**BACnet Errata**  
**ANSI/ASHRAE STANDARD 135-2016**  
**A Data Communication Protocol for Building Automation and Control Networks**

February 5, 2020

This document lists all known *errata* to ANSI/ASHRAE Standard 135-2016 as of the above date. Each entry is cited first by clause, then page number, except where an erratum covers more than one clause. The back page marking identifying the electronic publication of Standard 135-2016 is “Product code: D-86451 6/16”.

- 37) **Clauses 15.8.1.1.4.3.3, 15.8.1.1.4.3.4, 15.8.1.1.4.3.5**, p. 695, 696: The time scale in the examples is erroneous.

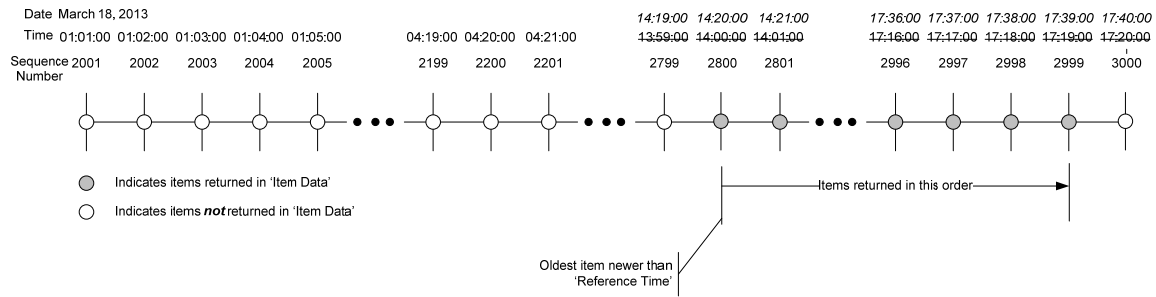
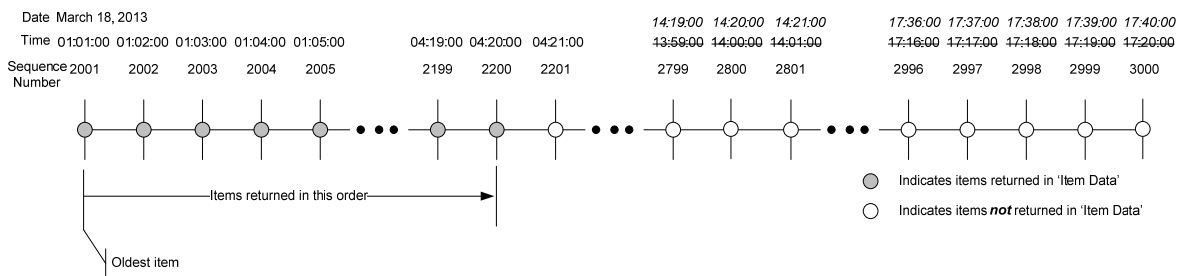
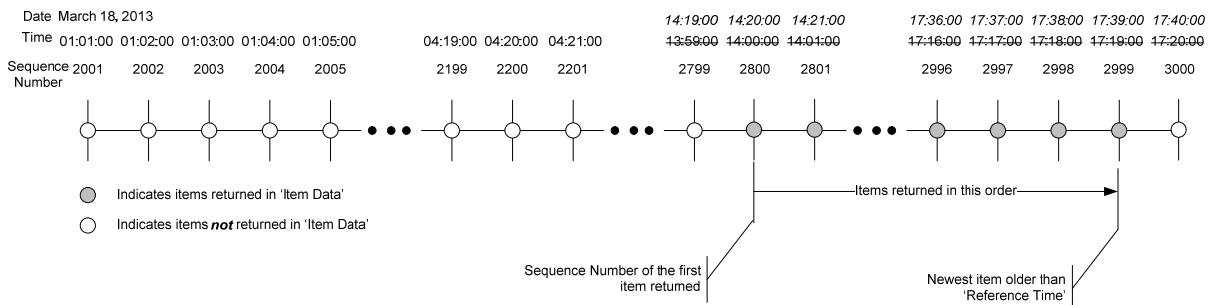
Assume a device contains a list with 1000 items and is capable of returning 200 items in a ReadRange response. The ReadRange service request contains a 'Reference Time' = March 18, 2013, ~~14:19:00~~ *14:19:00* and 'Count' = 300. The resulting ReadRange service response contains 200 items from March 18, 2013, ~~14:20:00~~ *14:20:00* to March 18, 2013,

~~17:19:00~~ 17:39:00 with FIRST\_ITEM = FALSE, LAST\_ITEM = FALSE, and MORE\_ITEMS = TRUE. The 'First Sequence Number' = 2800.
